Subject: VIBRATION DURING ACCELERATION	Bulletin No: 03-001/13
	Last Issued: 01/30/2013

BULLETIN NOTE

APPLICABLE MODEL(S)/VINS

2636a

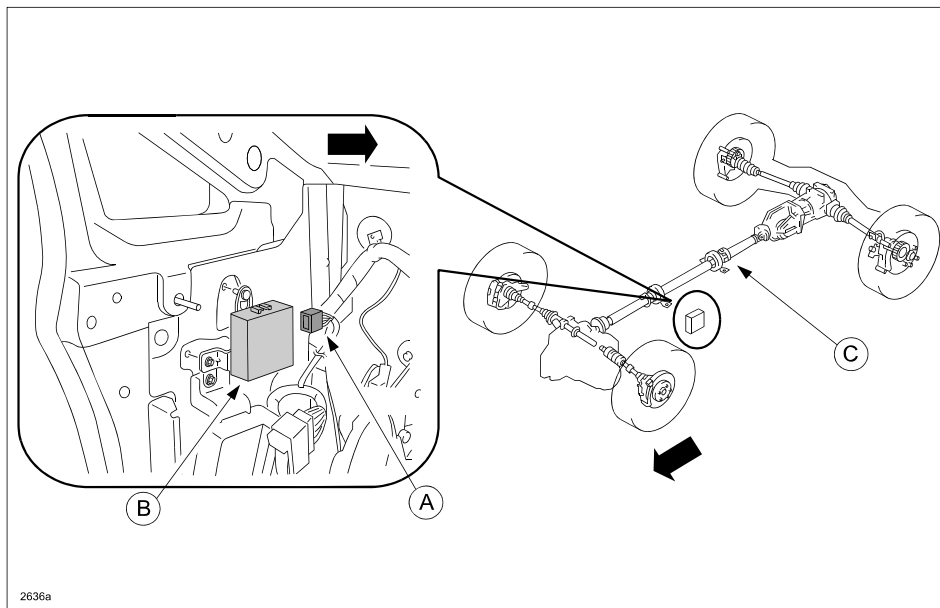
1. Before test driving the vehicle, remove the drivers side front scuff plate (inner) and front side trim to gain access to the 4WD control module.
2. Drive the vehicle to confirm the vibration occurs in 4WD.
3. Disconnect the connector (A) for the 4WD control module (B).

4. Test drive the vehicle again.
 - If the vibration is gone, replace the propeller shaft with a new one according to the online instructions on MS3 or the Workshop Manual (section 03-15 PROPELLER SHAFT REMOVAL/INSTALLATION).
 - If the vibration remains, continue troubleshooting according to the online instructions on MS3 or the Workshop Manual.
5. Reconnect the 4WD control module connector and install the other parts in the reverse order of removal.
6. Connect the M-MDS and clear the DTCs (U0114.8 and/or U0114.20) that were stored when the 4WD control module connector was disconnected in Step 3.
7. Verify repair.
